PROPOSED S4.56 MODIFICATIONS LIST:

S4.56 MODIFICATIONS

9-11 VICTORIA PARADE, MANLY, NSW

NORTHEAST ELEVATION

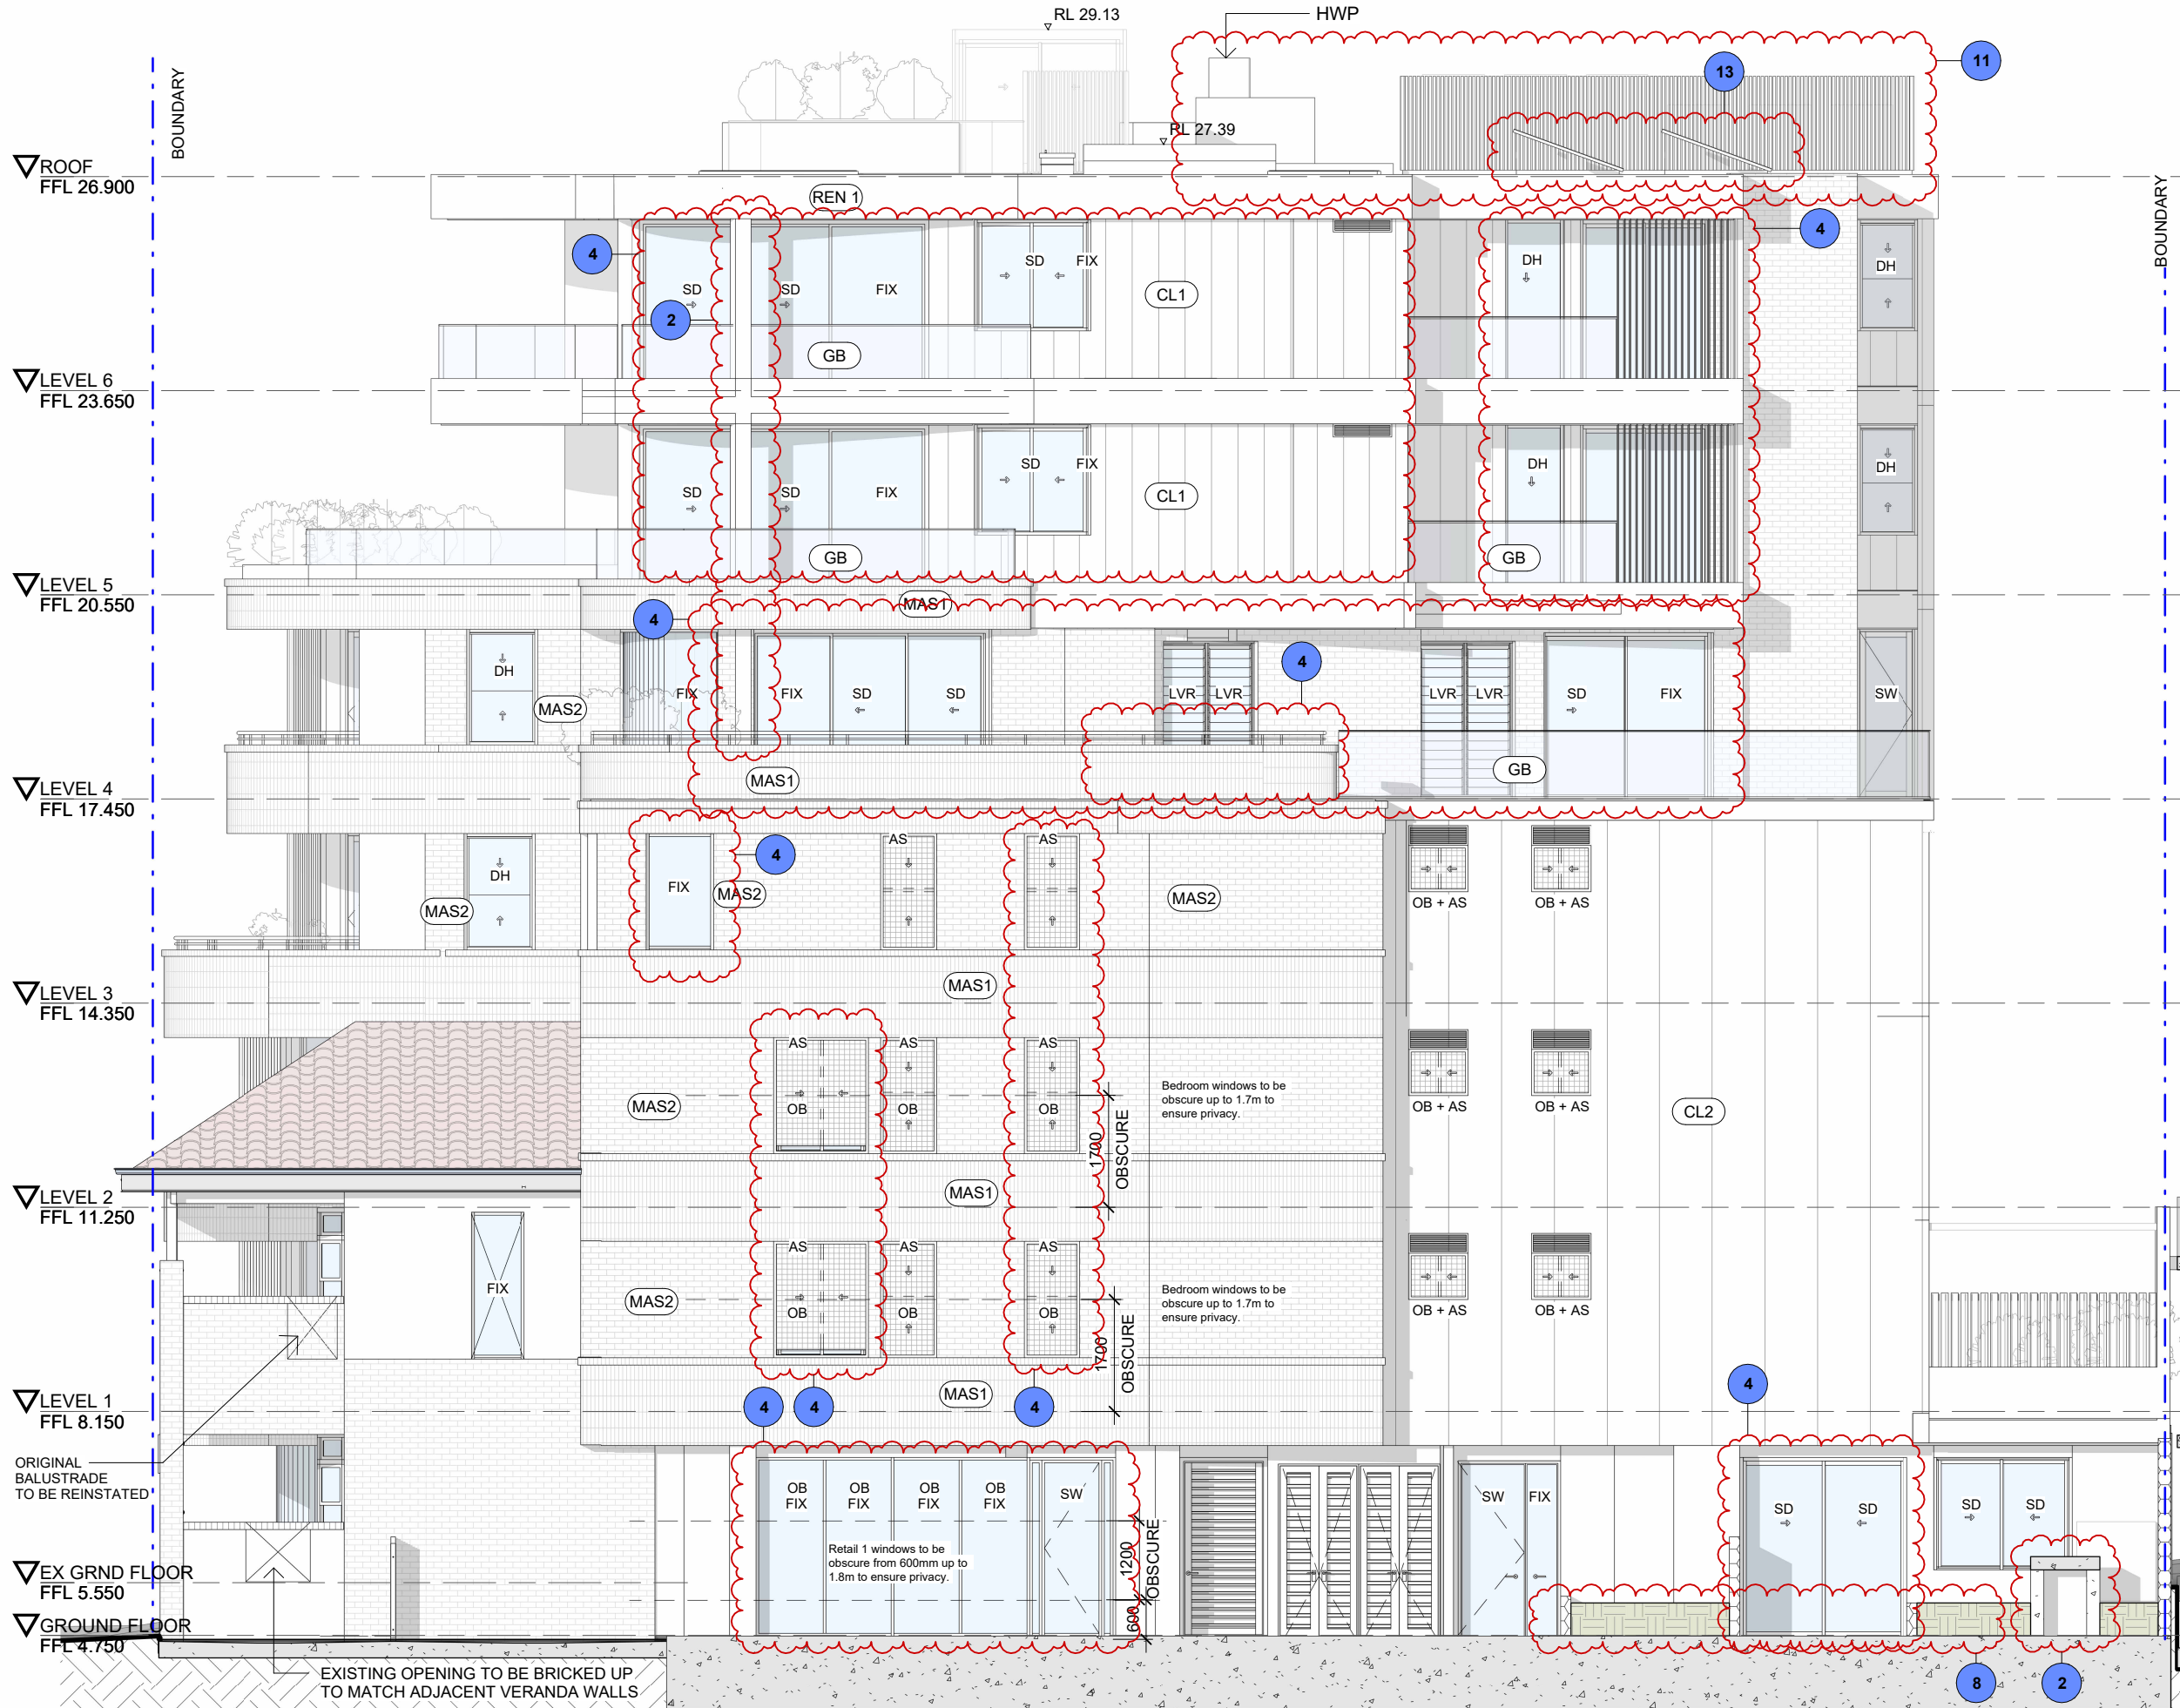
1. Revised fire hydrant booster location
2. Revised internal layouts and associated services and structure.
3. Amalgamation of Units 10 & 11 on Level 4 to a single SOU.
4. Revised window size and location in response to revised layouts.
5. BBQ added to terraces
6. Skylights added
7. Revised Core position and related walls
8. Revised landscaping area
9. Revised fire stairs
10. Revised storage cages
11. Added HWP and moved AC units
12. Addition of blade wall
13. Addition of Photovoltaic Panels
14. Proposed enclosure of parking spaces into private garages.

SECTION B

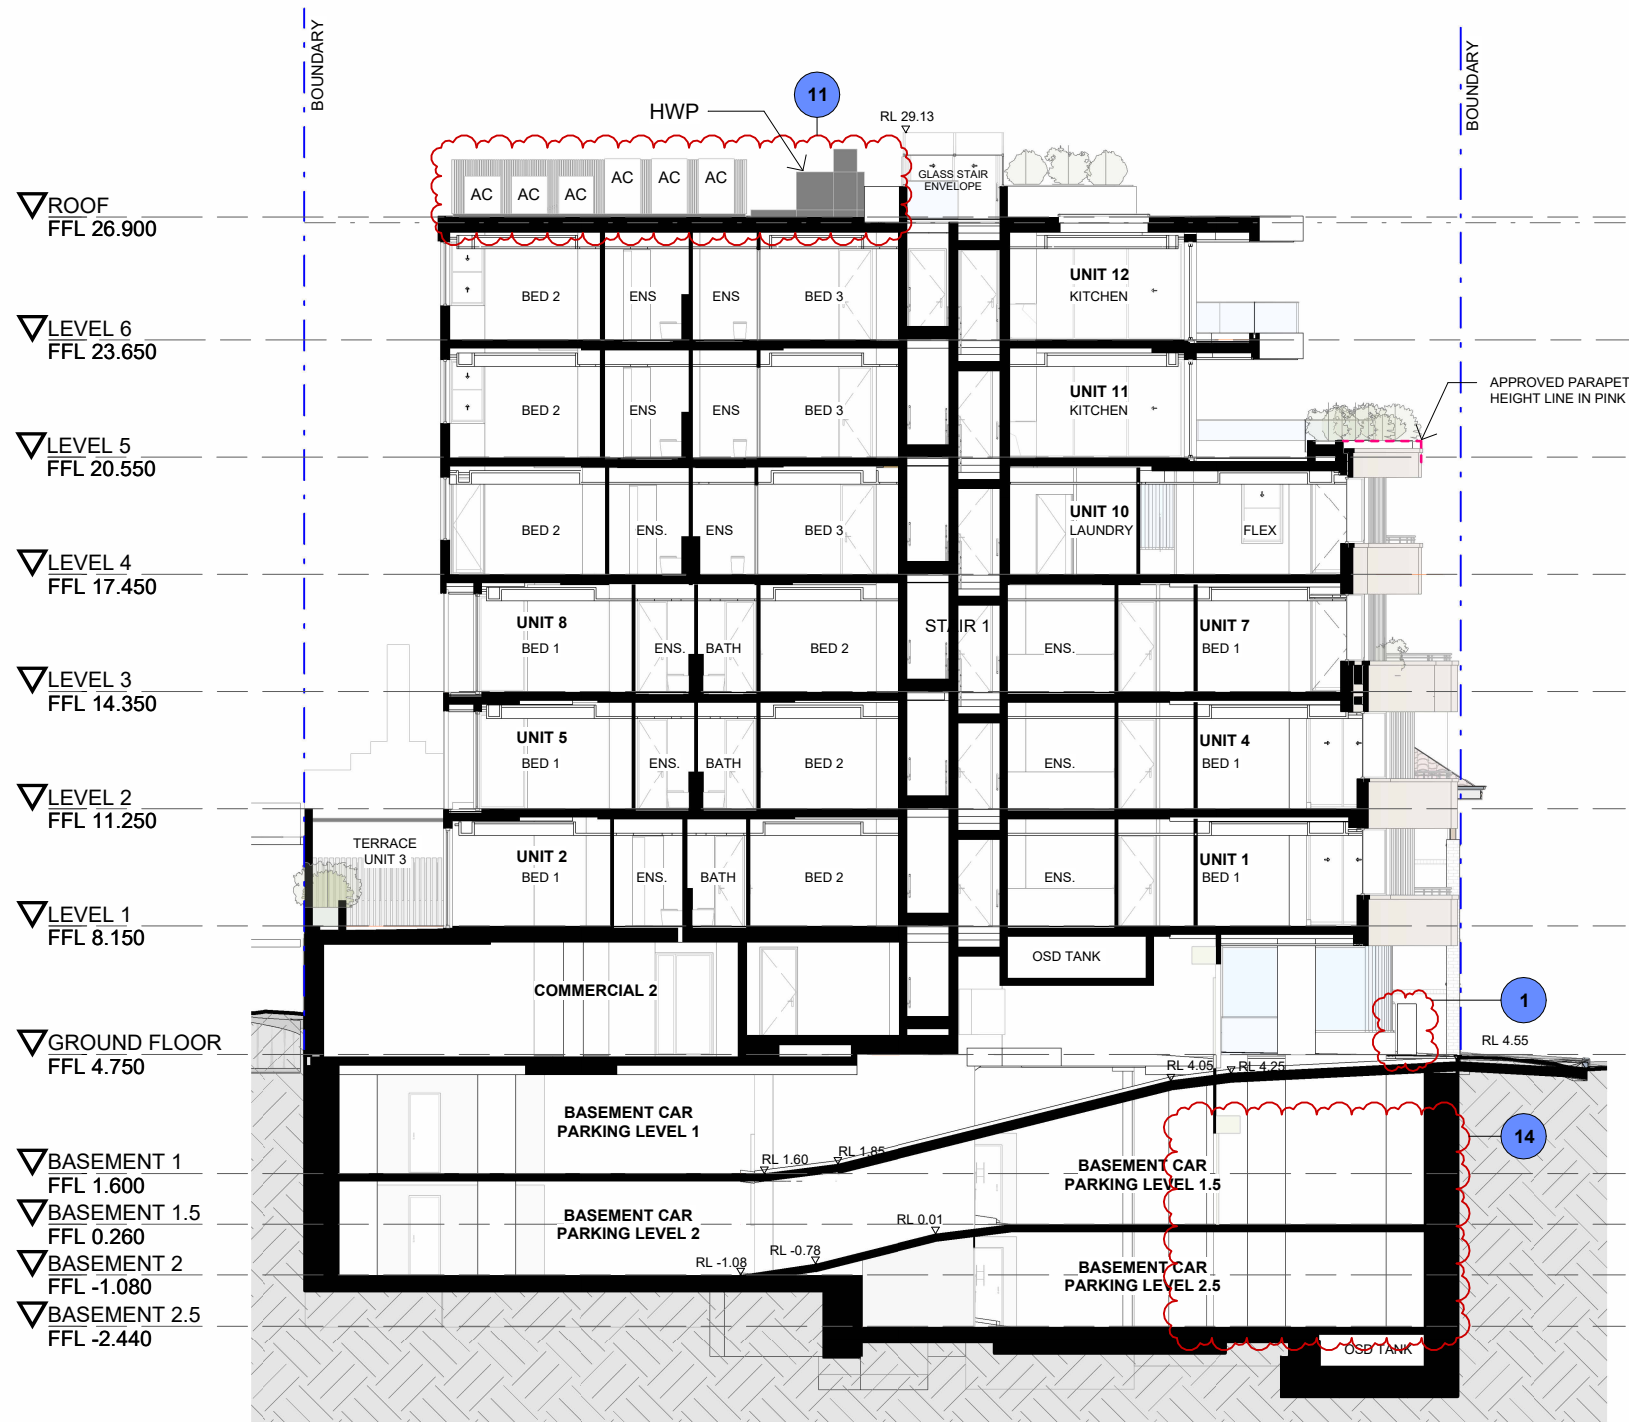
1. Revised fire hydrant booster location
2. Revised internal layouts and associated services and structure.
3. Amalgamation of Units 10 & 11 on Level 4 to a single SOU.
4. Revised window size and location in response to revised layouts.
5. BBQ added to terraces
6. Skylights added
7. Revised Core position and related walls
8. Revised landscaping area
9. Revised fire stairs
10. Revised storage cages
11. Added HWP and moved AC units
12. Addition of blade wall
13. Addition of Photovoltaic Panels
14. Proposed enclosure of parking spaces into private garages.
